SB, New Cover, WS440, WS482, PP440, PP490, PP492, 2024-03

SYMPTOM/DESCRIPTION

Fig. 1: Old version.

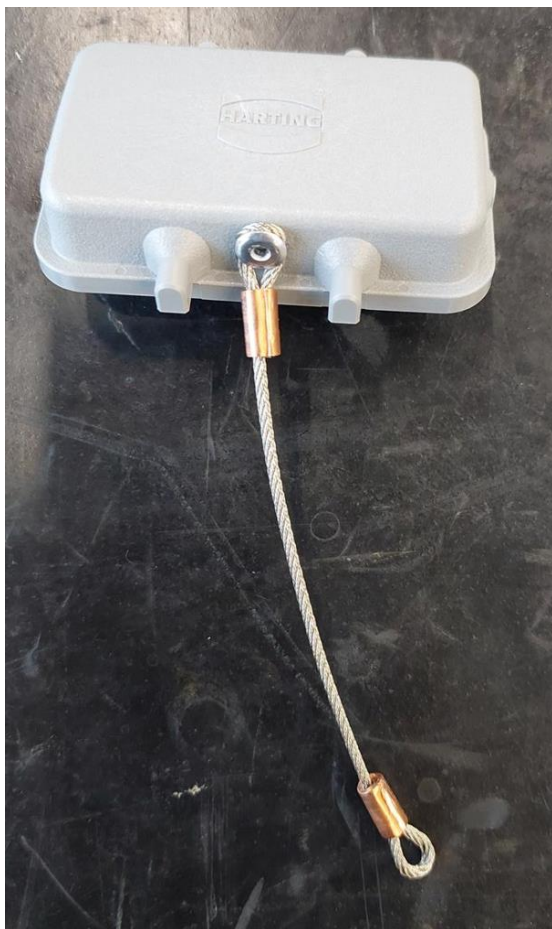
New updated position of the rivet on the HARTING contact on Wall Saw, Power Pack and orange cord. This new position will improve the situation with broken covers.

Description	Old Part No.	New Part No.
COVER	575335401	575335402
